Subject: Two piece engine bearer with direct attachment of the Bing-fuel pump

Applicability: **ASW 28-18E**, TCDS EASA.A.034,
all serial numbers upon which TN10 Action A has **not** been applied

ASW 27-18E, TCDS EASA.A.220,
all serial numbers upon which TN5 Action A has **not** been applied

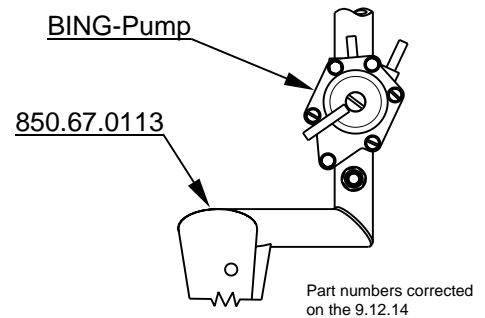
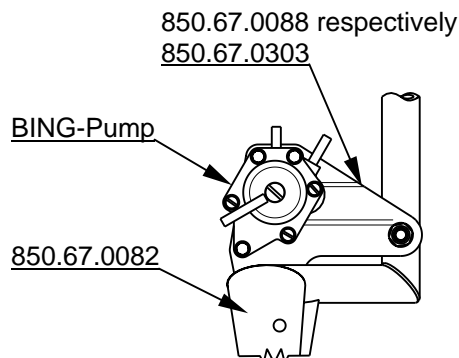
Reason: The left part of the engine bearer is replaced with a part, which has a direct attachment for the BING fuel pump (SOLO part nr. 2300363). This makes the separate attachment (a part made either from steel or FRP) for the fuel pump obsolete.

Action: The left part of the engine bearer (850.67.0082) is replaced by the part 850.67.0113. The BING fuel pump can directly be screwed to the engine bearer. The part 850.67.0303 respectively 850.67.0088 is removed. The length of the fuel hose and fire protection hose must be adopted.

A new fuel hose with fire protection hose is necessary between the stainless steel tube in the FRP sword and the inlet of the fuel pump. Usually the hose becomes too short for the new position of the pump.

The connection components necessary to attach the pump are listed in drawing 850.67.0113.

Three washers $\varnothing 8 \times \varnothing 16 \times 2$ and three new self locking nuts M8 (2x "Stahlstop" below and 1x "Poly-stop" top) are necessary, where the part "attachment of the fuel pump" is removed.
